December 22, 1995

DEPARTMENT OF
ENVIRONMENTAL
QUALITY

Re: WQ-WCS-Materials: Concrete Septic Tank
Concrete Dosing Septic Tank
Concrete Septic & Dosing Tank
Concrete Holding Tank

SIDE VIEW 1500 GALLON TWO COMPARTMENT TANK

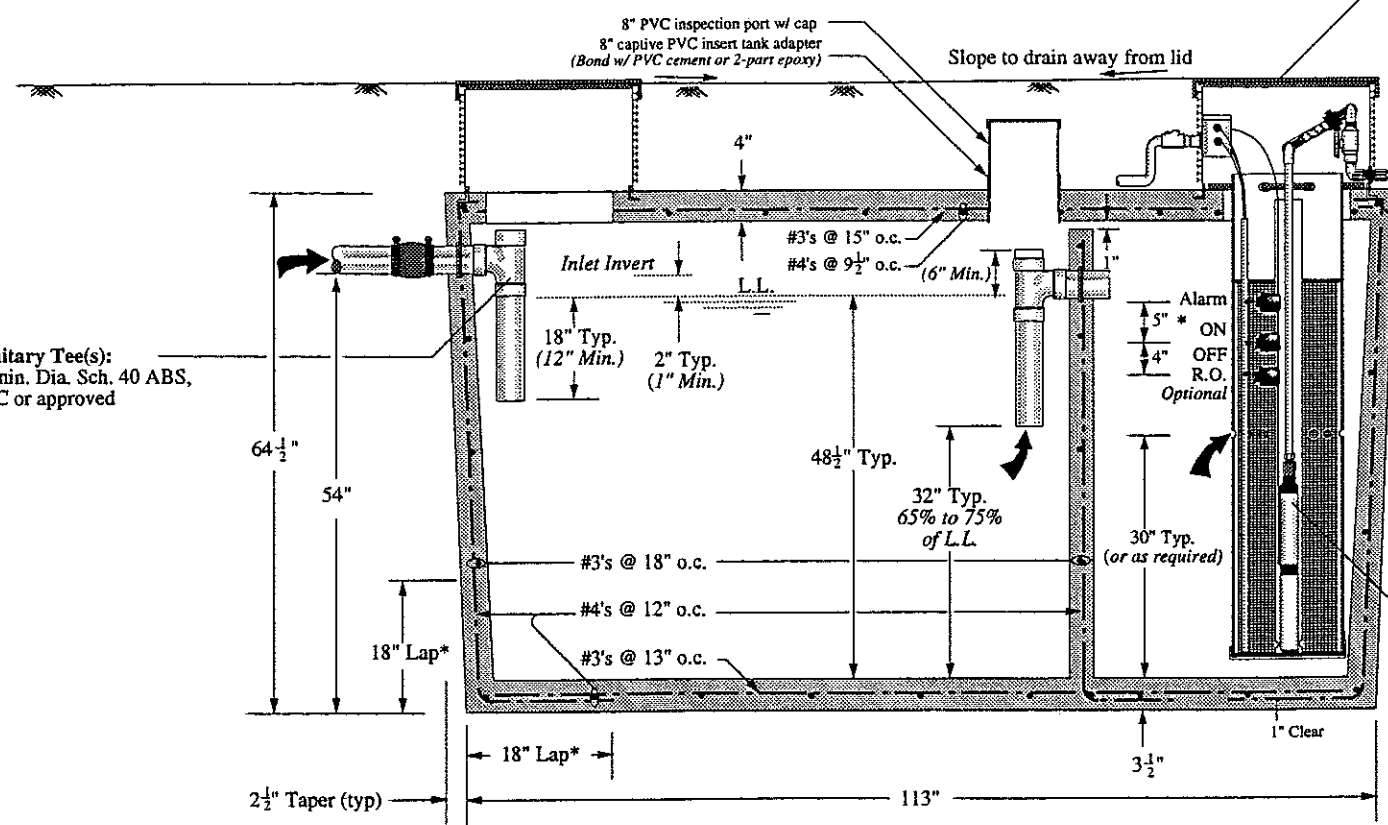
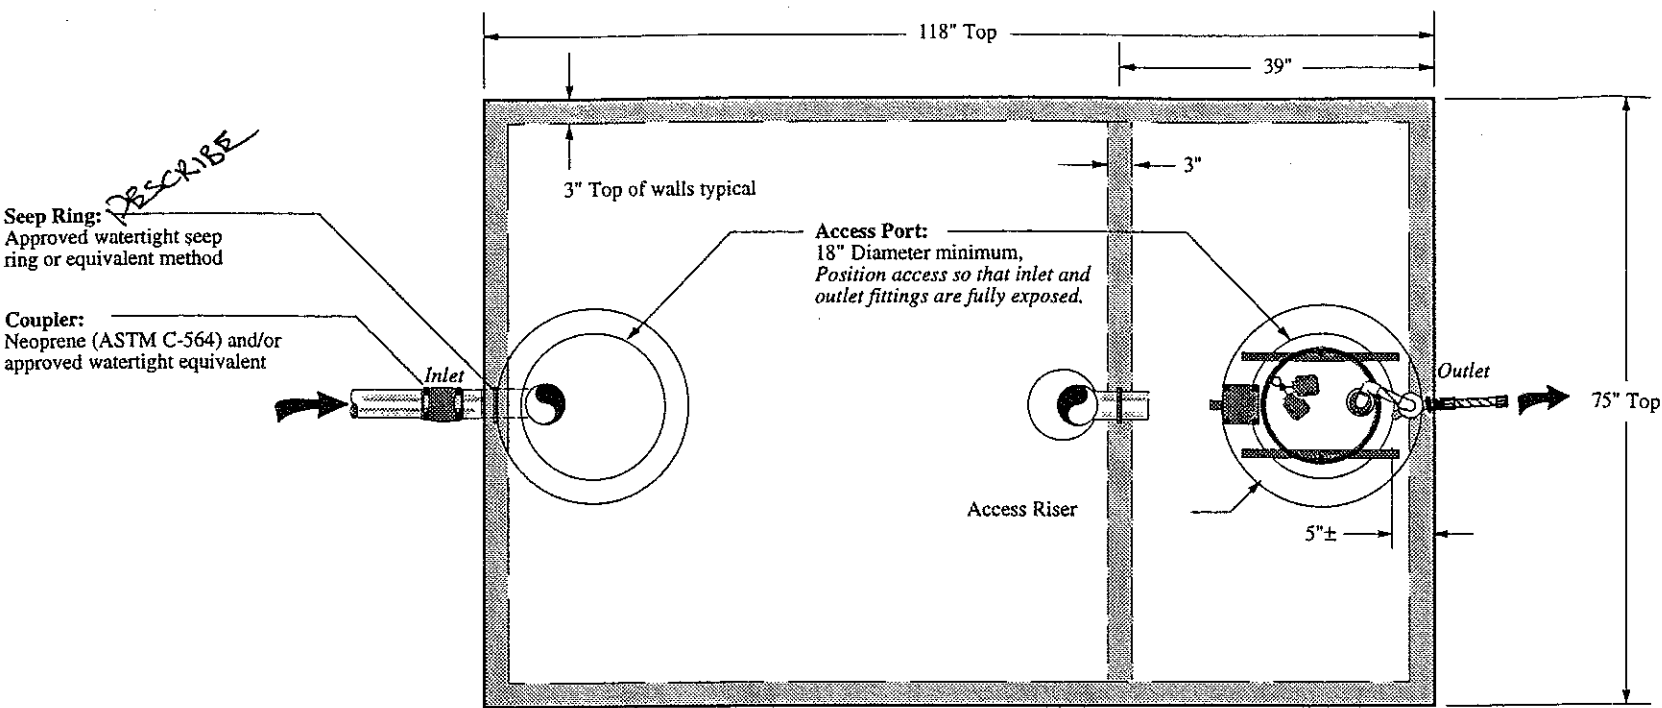
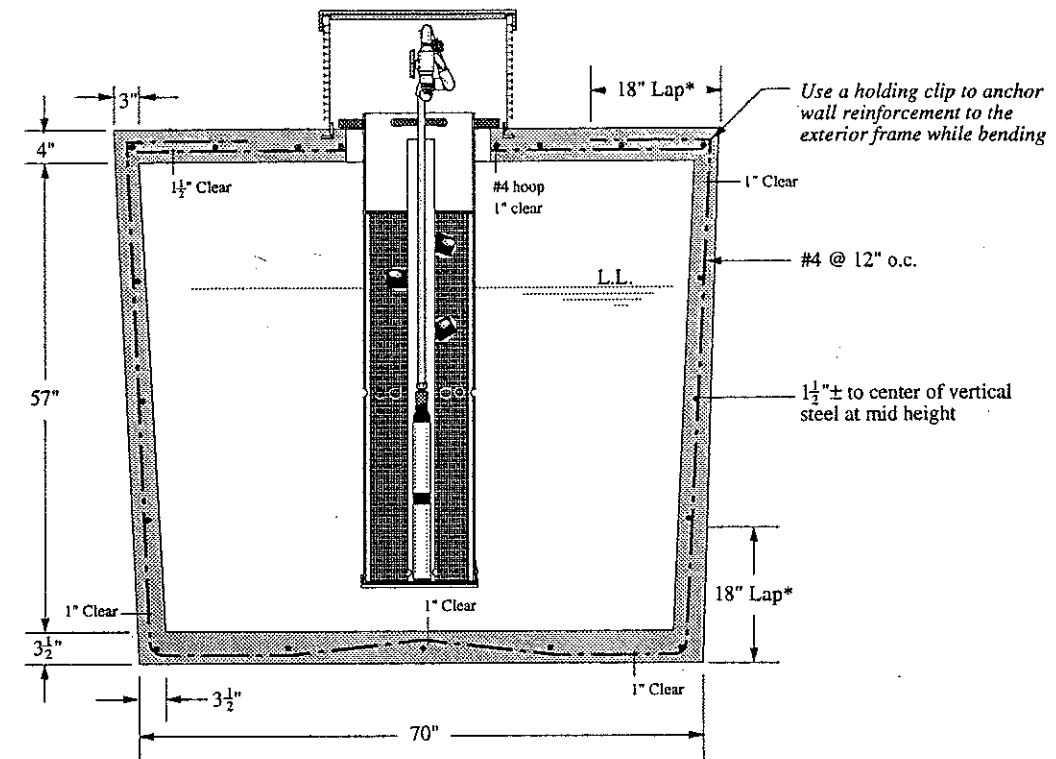
5. You are to deliver to the purchaser a fully assembled and complete tank, and provide the tank riser(s) and cover(s).
6. A seep ring is shown in the plans where the plastic inlet and outlet fittings pass through the wall, however it is not specified. Provide this office with a sample of the ring you intend to use.

7. The inlet and outlet "Tee" fittings shall be either Sch. 40 ABS or Sch. 40 PVC plastic.
8. The mastic sealant used at the wall joint in the 3,000 gallon tank is not specified. Provide this office with the specification sheet for the sealant you intend to use.

13. In the "General Notes" listing of methods that may be used to insure tank submergence in areas with high groundwater, method 5 is not an optional method that may be used in Oregon. It shall not be described in the installation manual.
14. The 1,000 gallon and 1,250 gallon tanks are not accepted for use as holding tanks, unless such use is consistent with the requirements of OAR 340-71-160(11).
15. Each tank shall be marked on the uppermost tank surface over the outlet with the liquid capacity, date of manufacture, burial depth limit, and either your full business name or the assigned number 220 if manufactured at the Eugene plant. If manufactured at the plant in Wood Village, the assigned number to use is 726.
